City-Prepared Public Access Concept

ROCK CREEK COVE HOSPITALITY
PLAT AMENDMENT

SHEET TITLE: **PLAT AMENDMENT**

SHEET: **C1.1**

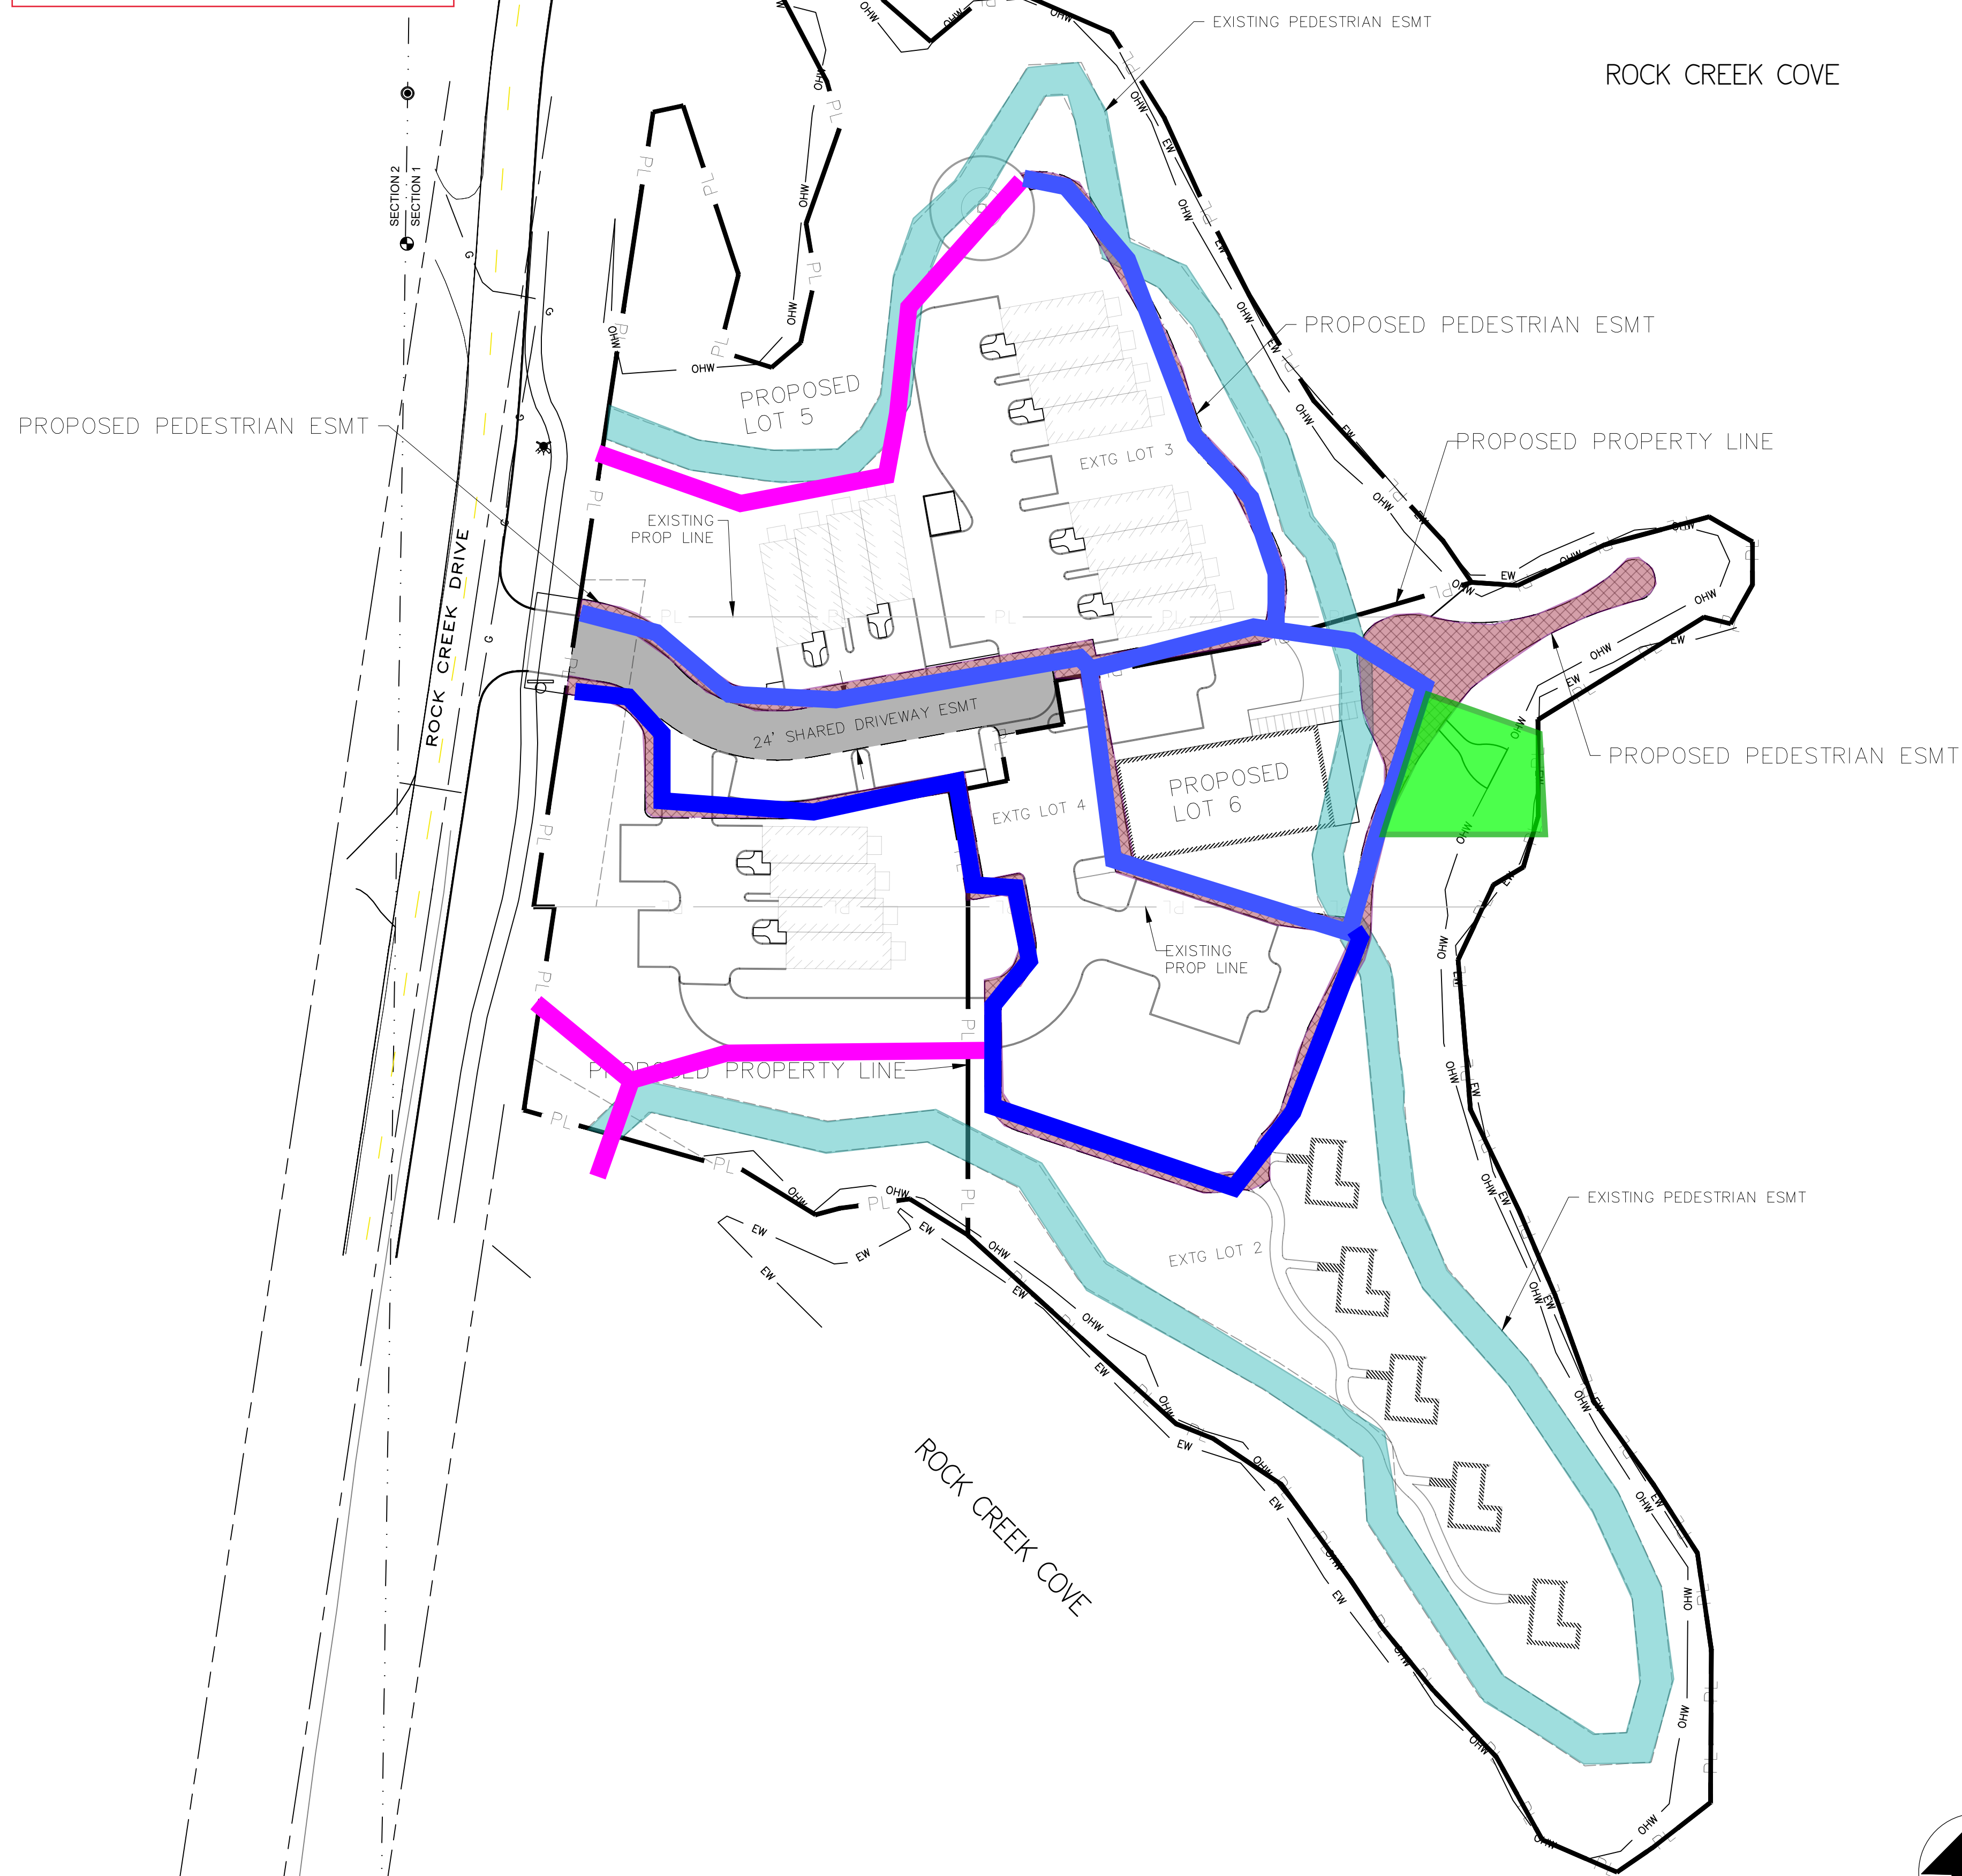
Existing Pedestrian Easement
	Proposed Pedestrian Easement
	Potential ADA loops, lollipops, & out-and-backs
	Potential gravel continuous
	Potential physical access

**Color annotations provided by City staff based on applicant's 6/4/20 concept*
